STAFF REPORT and NOTICE OF DECISION

Seven Wells PH 6 Post Decision Review (PDR)

File No. MASTER-22-0070, PLZ-22-0108

FIGURE 2: SEVEN WELLS PH 6 MODIFIED SITE PLAN

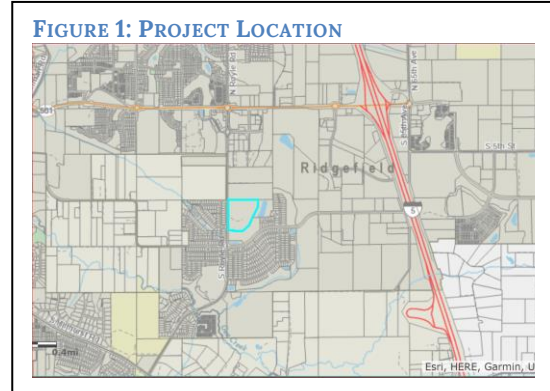
Staff statement: The applicant proposes to create frontages of 40 ft. or 45 ft. for lots 1- 11 and 15, less than the 50-foot minimum allowed in the RLD-8 zone. Other lots will have street frontages of 50 feet or more. The proposal will not increase the lot count in PH 6; there are 63 lots. The proposal slightly alters the location of the proposes open space, Tract J, and enlarges the tract from 7,348 sq. ft. to 7,959 sq. ft., an increase of 611 sq. ft. (See, Comparison of PH 6 in PLZ-16-0035 and proposed modifications, at the end of this report.)

Lots 1-11 and lot 15 are less than the minimum allowed in the RLD-8 zone. However, the PUD code, RDC 18.401.100.A.4 and 18.401.100.A.5 provide a mechanism to reduce the minimum lot dimensions. The proposed modifications are consistent with the intent of RDC 18.401.100.

6. The applicant shall provide a note on the final plat for PH 6 stating that the lot widths for lots 1 – 11 were approved by the Final Decision for PLZ-22-0108, Master File PLZ-22-0070.
